# COMBINED LINWOOD/EASTERN INTERCHANGE & US 50/RED BANK INTERCHANGE FOCUS AREA ADVISORY COMMITTEE MEETING NOTES

EASTERN CORRIDOR SEGMENTS II AND III (PID 86462)

## MEETING #3 NOTES

Sept. 7, 2018

### Figure BIKE-2A (Overall View)

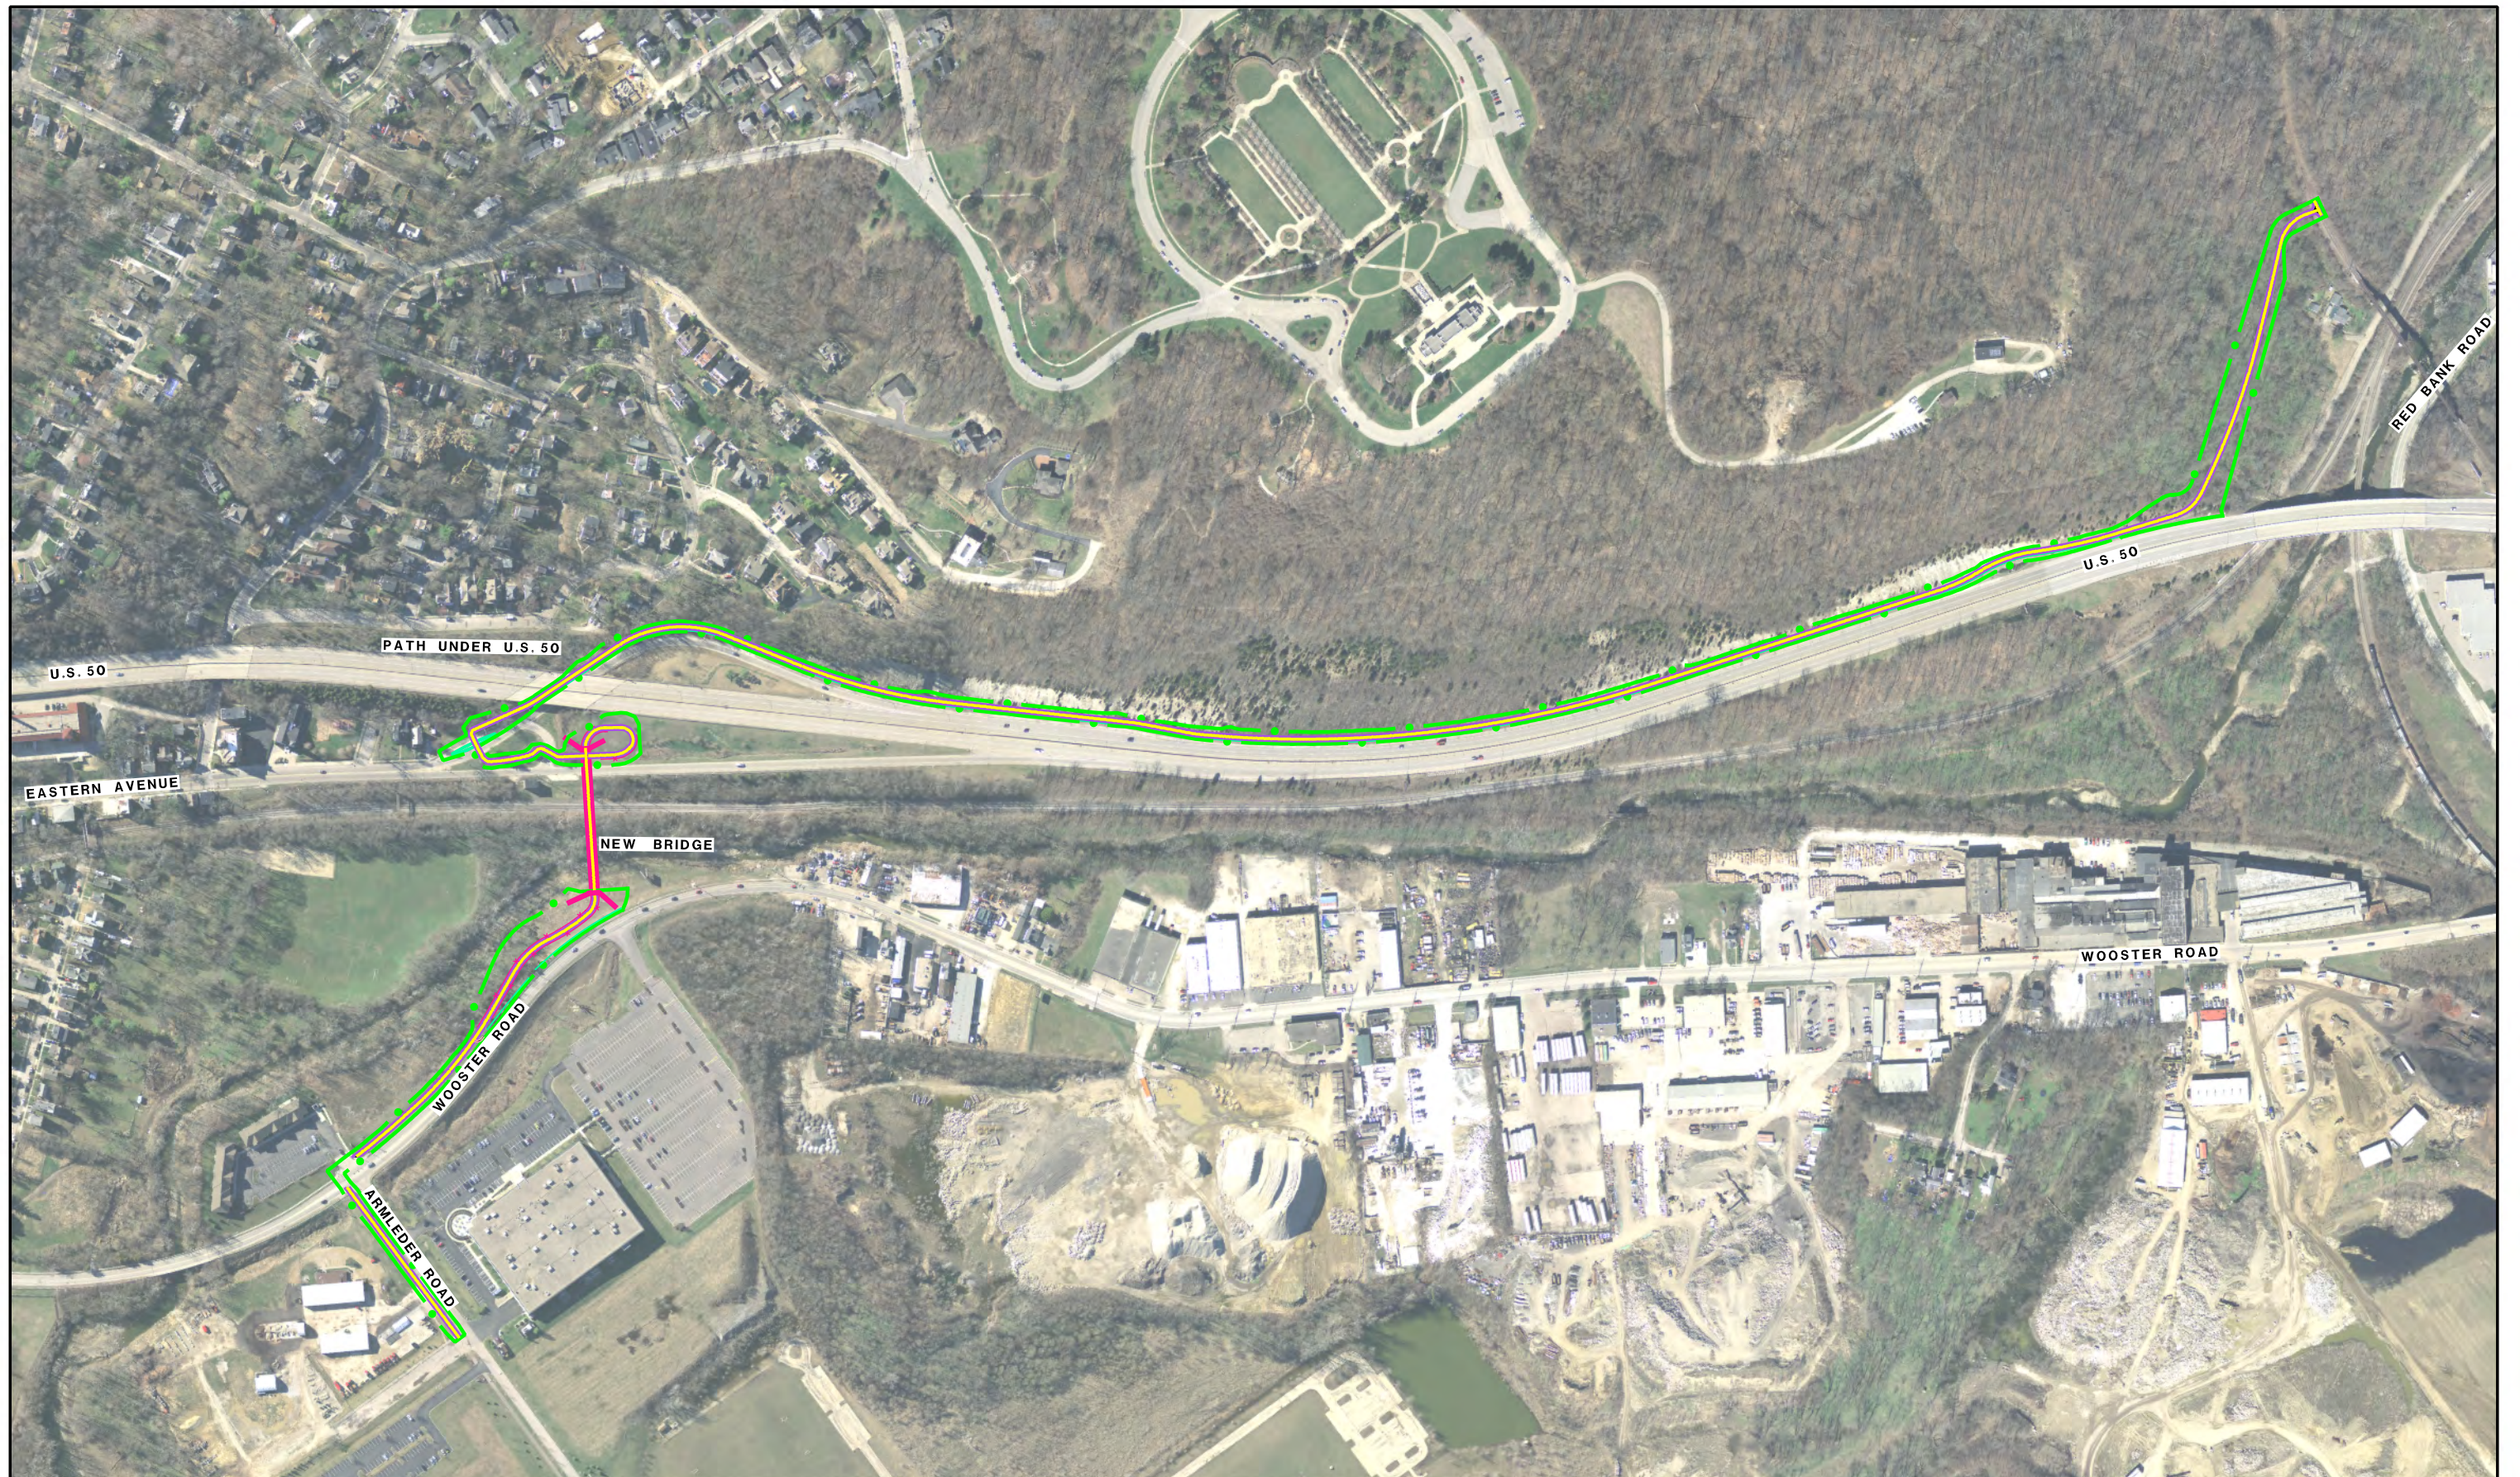
- This concept requires construction of a new bridge crossing from Eastern Avenue to Wooster Road. The bridge would be located immediately east of Linwood Park.
- A shared-use path located next to US 50 would need to be separated by a physical barrier; concrete barriers are proposed. Installing concrete barriers would not impact the hillside or shoulder along US 50, but would require modification of the city gateway.
  - One Committee member expressed concern that cyclists would be traveling a long way without an option to exit the path. Another suggested that, even with the concrete barrier, cyclists might not feel safe, particularly with children traveling so close to vehicular traffic on US 50.

- Advance for public consideration.
- The connection between Eastern Avenue and Armleder will be split off into new Concept BIKE-1a.

**Figure BIKE-2B**

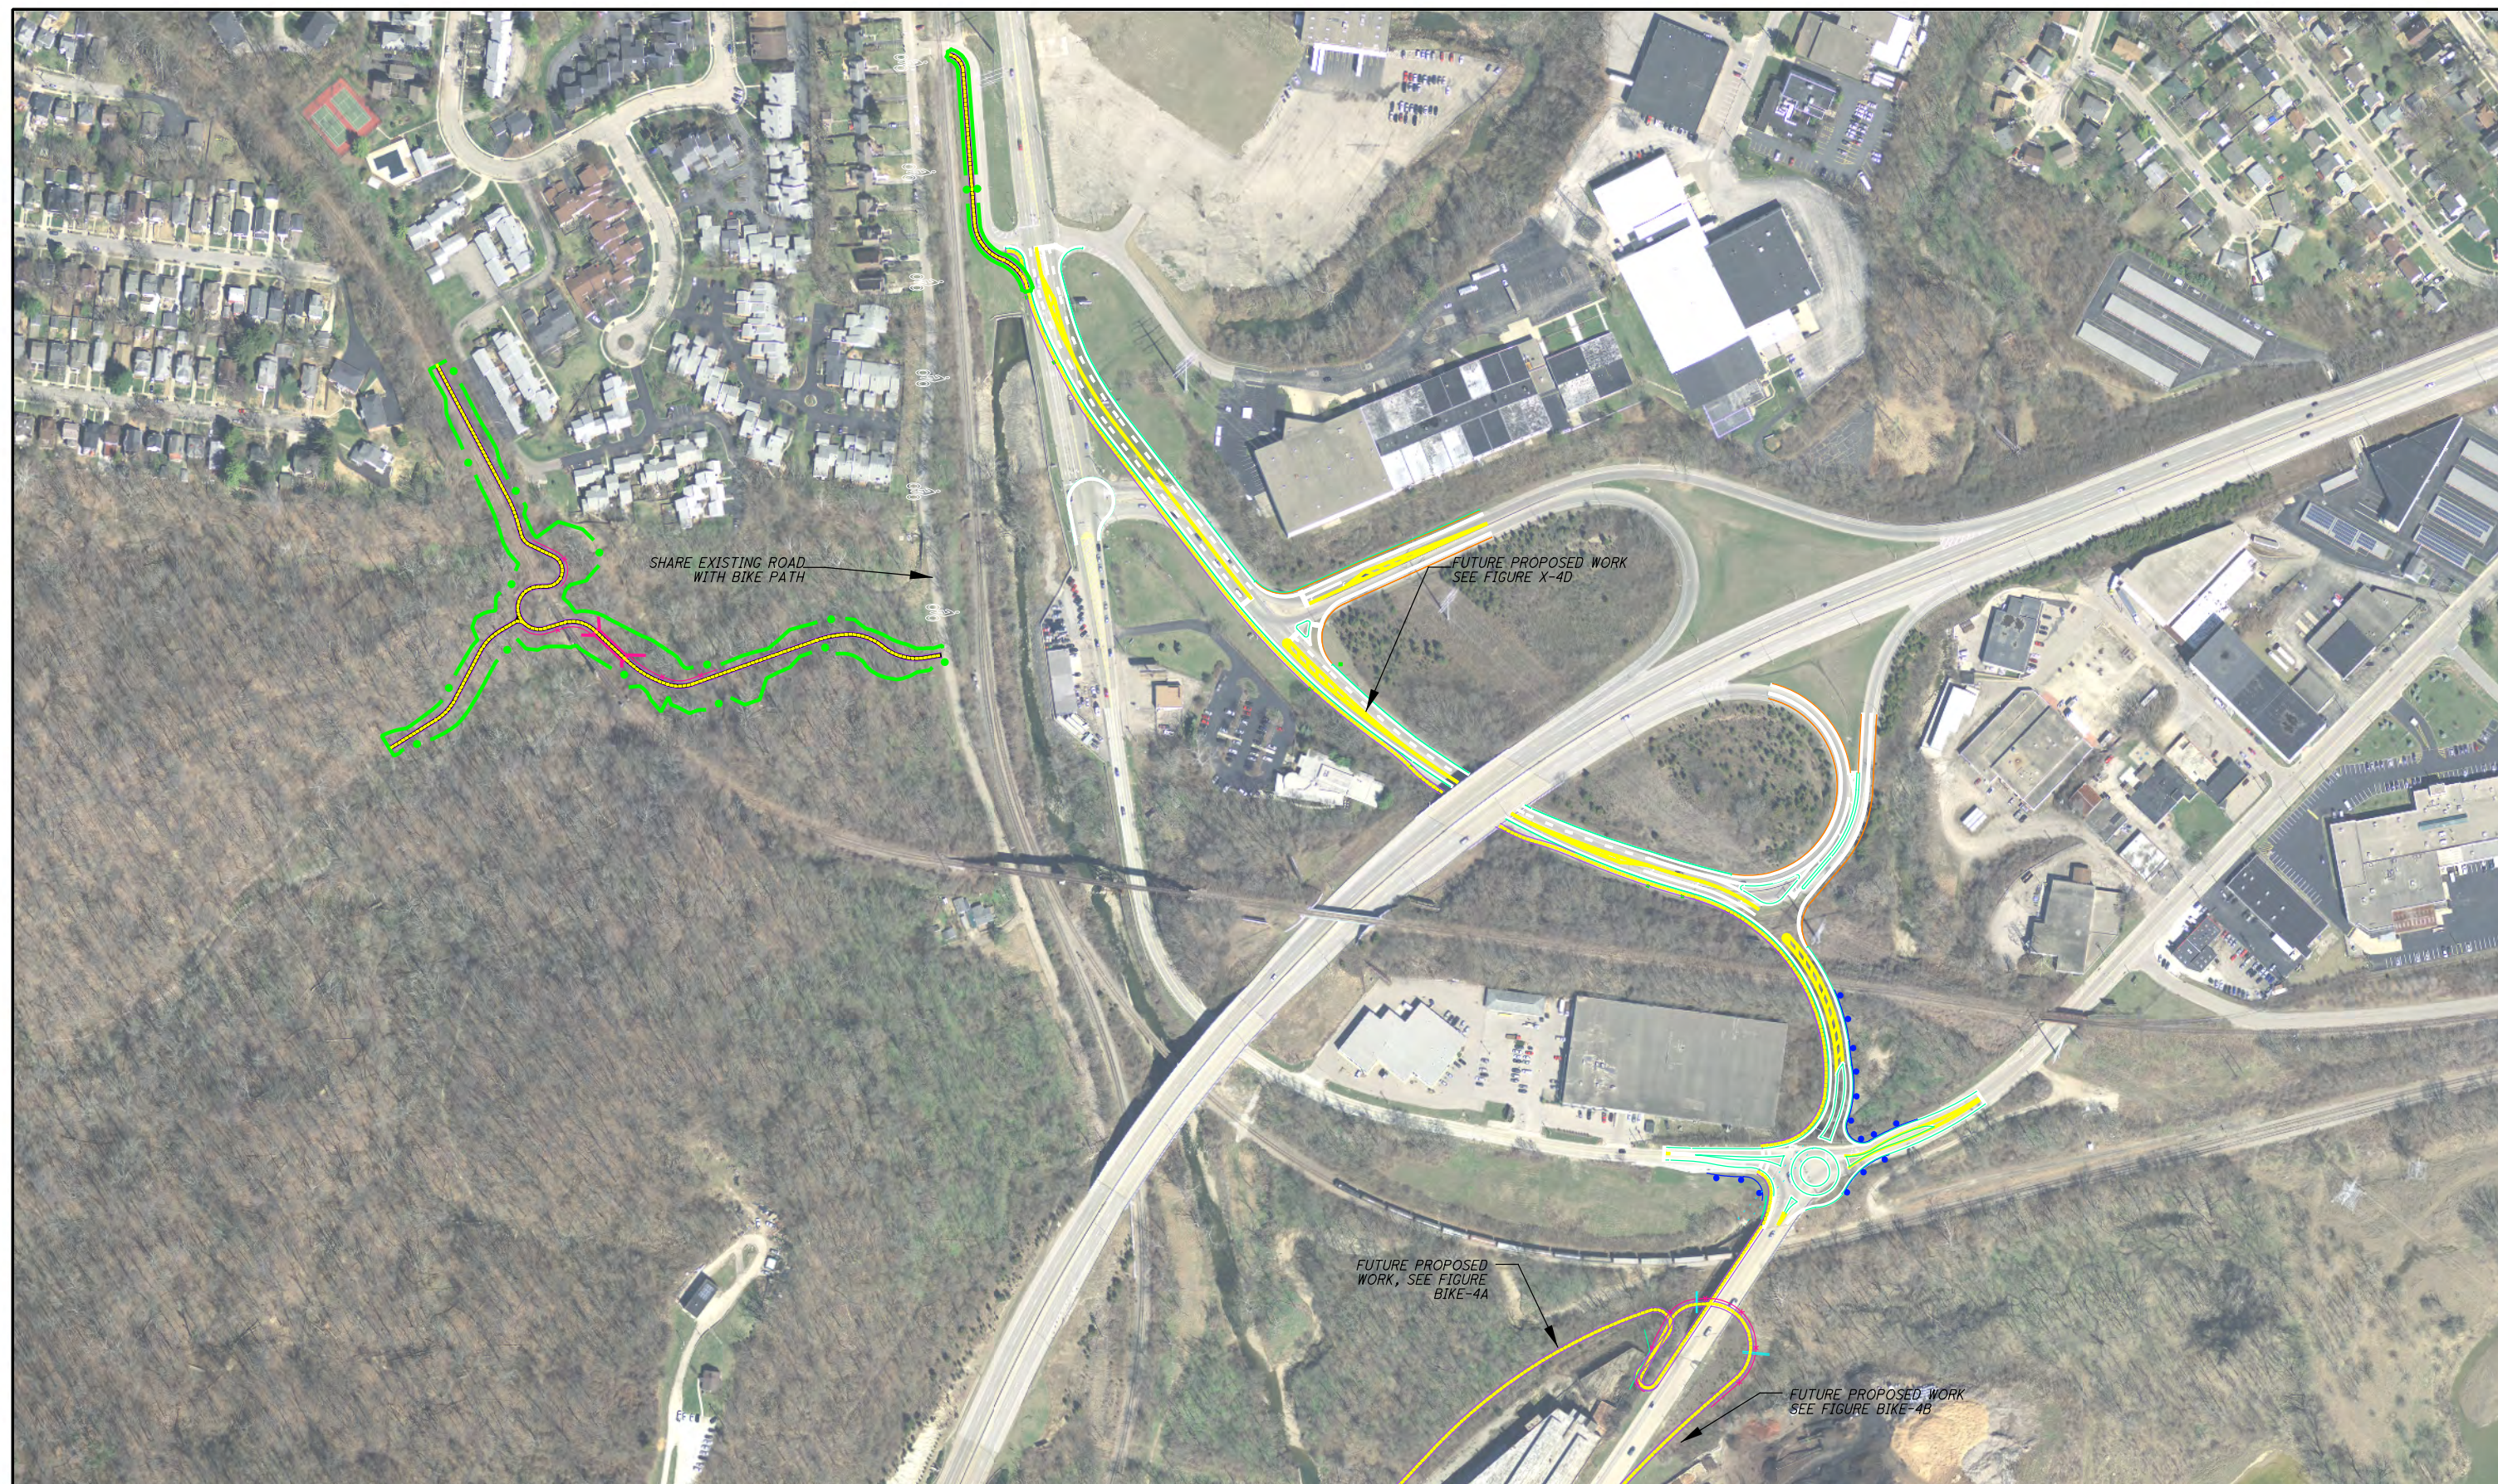
- A Committee member asked if instead of following the new connector, would it be possible to continue the path along Old Red Bank Road US 50 of the US 50 ramp. ODOT shared that there is an existing abutment wall under US 50 that is a barrier to a bike path connection.

- The BIKE-2b, BIKE-4a and BIKE-4b concepts would need to be construction in conjunction with other projects to complete a full connection. Cost estimates for the necessary combinations are:

- Advance for public consideration.
